## CN20006: RTG4 Family Important Changes

April 22, 2020

This document describes the following three changes to the RTG4 product family.

**Figure 1 • RTG4 Programming Options GUI**

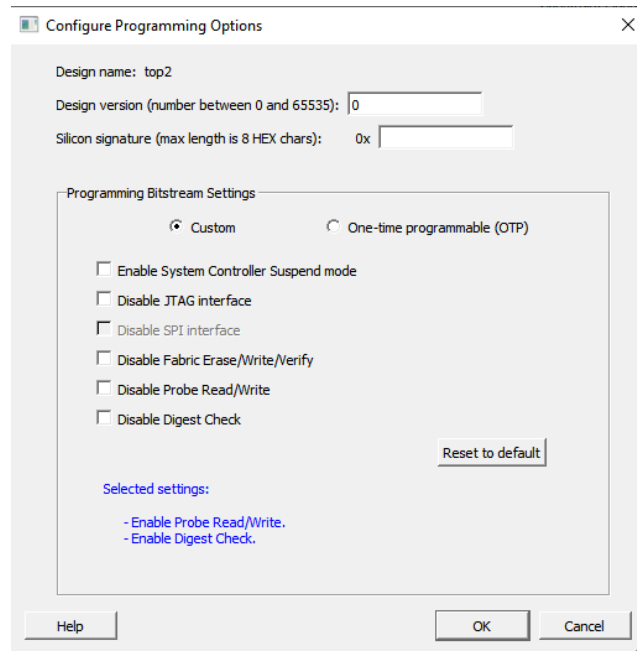
- If System Controller Suspend Mode (SCSM) is enabled (which automatically disables the JTAG interface), the bitstream generated after configuring I/O states during programming can prevent all further JTAG access, and thus permanently prevent further device programming with Scan Chain failure and "TDO stuck at {0,1}" msg.

- If Fabric Erase/Write/Verify is disabled, the bitstream generated after configuring I/O states during programming can permanently prevent further JTAG programming with the “Operation has been disabled by programming bitstream settings” message.

- If Probe Read/Write is disabled, the bitstream generated after configuring I/O state during programming can prevent fabric (probe and SRAM) debug using SmartDebug, causing the following messages:

- For RTG4, this issue only occurs if running “Configure I/O States During JTAG Programming” in Graphical User Interface (GUI) mode.
- There is no issue if the “Configure I/O States During JTAG Programming” GUI is not used, no issues in Tcl scripted mode.

Do not program any further RTG4 devices with programming files (Libero SoC v12.0 to v12.3) using I/O states during programming GUI combined with the programming options listed above. Upgrade to Libero SoC v12.4, observe that all "Generate" and "Export" programming steps in the design flow will be invalidated, then re-run I/O States GUI and re-configure Programming/Bitstream options prior to Generating and Exporting new bitstreams.
